Evaluation of Electric Bus Depot Design for Bawana, Burari and East Vinod Nagar

Final Report

4.8 Response to Comments on Bus Depot Design Evaluation Report

Figure 1: Proposed Workshop area (Bawana Bus Depot)

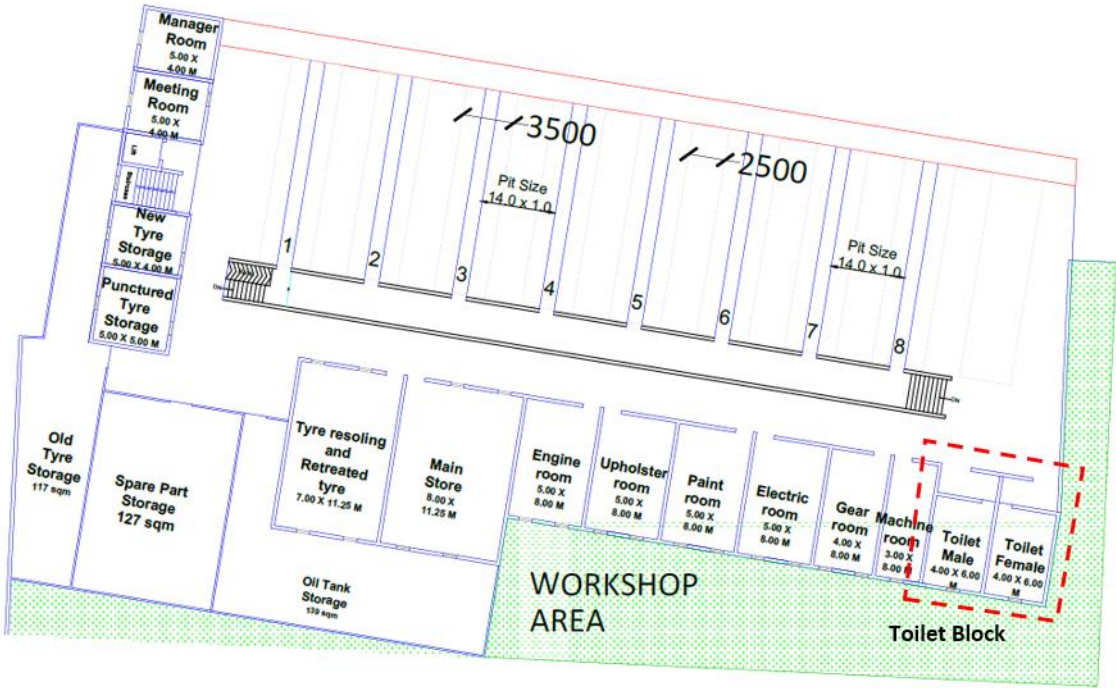
to 600sq.m. is required, in addition a space for 6 transformers totaling 120 sqm (4m X 5m each) is required to be provided. Each electrical charging station needs a protected platform with a recommended minimum size of 2.5m X 2.5m, and it is suggested the number of bus bays served by charging stations should be at least 60% of the total number of buses in the depot¹. Thus, charging stations provided between the buses in the central aisle have a potential to serve more buses per station, thereby minimizing the costs involved.

Figure 4: Crew and admin staff circulation in Admin block (Bawana Bus Depot)

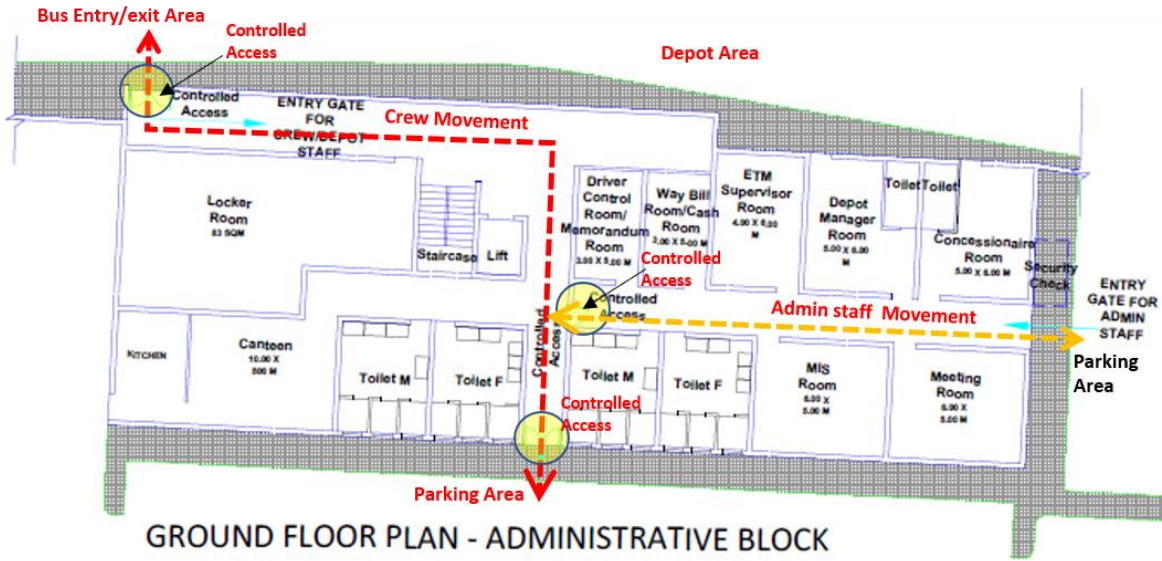
<p>site footprint. However, utility of toilet block is not clear as toilets have been provided in workshop, restroom and admin block.</p>	<p>two functions do not interfere with each other. Such admin blocks can be up to 3 story tall. Workshop block should have its separate toilet facilities for service staff (Refer Figure 1, Figure 2 and Figure 3)</p>
Comfort	<p>In the current design, rest room block is located adjacent to workshop block. This location of rest room block may cause uncomfortable environment for resting crew during night due to disturbance from workshop which operates throughout the night.</p>	<p>Provision of comfortable restroom for crew is essential for higher crew productivity as well overall safety. It is therefore recommended that restrooms should be as much isolated as possible from any major sources of noise and disturbance in the depot.</p>
Access control	<p>The site area is one continuous uncontrolled space, and common bus, staff, visitor and staff vehicle entrance is provided through one common gate. Entrance through this gate allows by design, unhindered access to all facilities/areas in the depot.</p>	<p>Access to depot area should be strictly restricted to only authorized and necessary personnel. This is possible by using the admin block as access control to the depot area. All personnel, visitors and staff need to pass through the admin block in order to gain access to the depot operational area. Thus, admin block should be the barrier/buffer between the private vehicle parking and bus parking with access-controlled gates on both sides (Refer Figure 4, Figure 5 and Figure 6)</p>

Figure 7: Two-way Bus circulation in existing proposal (Burari Bus Depot)

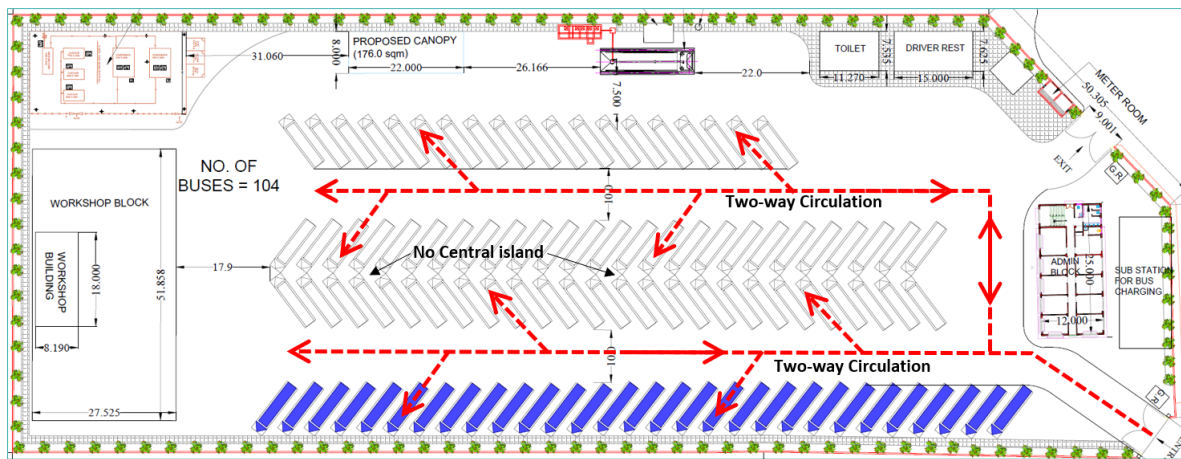
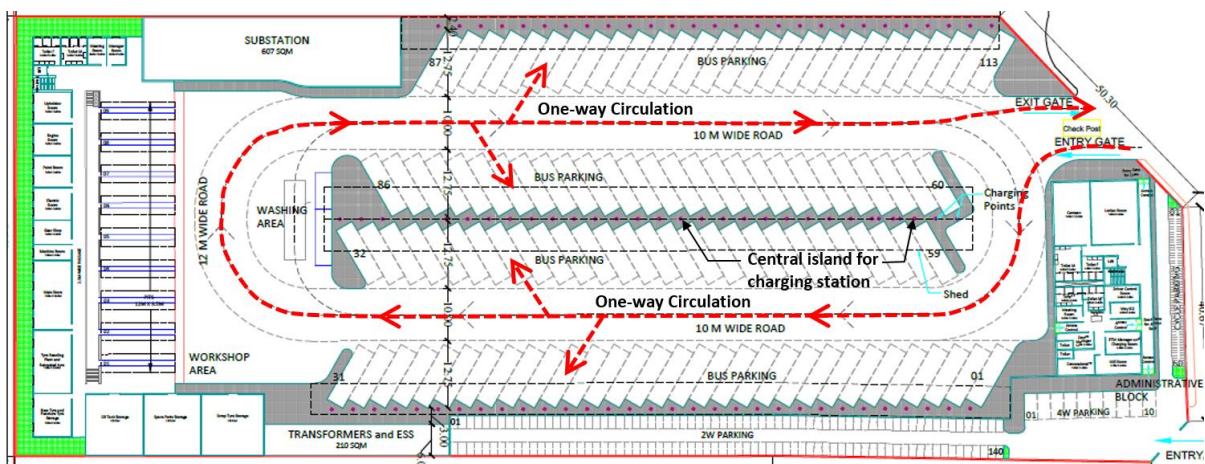
It is observed that because of the way the circulation of buses inside the depot is designed, the way the staff and visitor parking has been accommodated and the way block with different functions are laid out at different locations in the site, the space use efficiency of the plan suffers. This leads to loss of capacity by as much as 19 Buses (in Bawana depot). In addition it is observed that most functions and area allocation of functions is less than what is recommended by ASRTU (S G Architects, 2017). For example, ASRTU recommends lodging facilities (restrooms) and cafeteria, on site for 25% of the crew and lockers/change rooms for 100% of the crew. The area provided in the current designs ensures restroom provisions for only 5% of the crew and it excludes any provisions for crew change rooms and locker rooms. In addition, spaces and provision for many other functions in all or most of the three depot designs is missing. These include Sub-station area, defined staff parking and space for charging stations near bus parking.
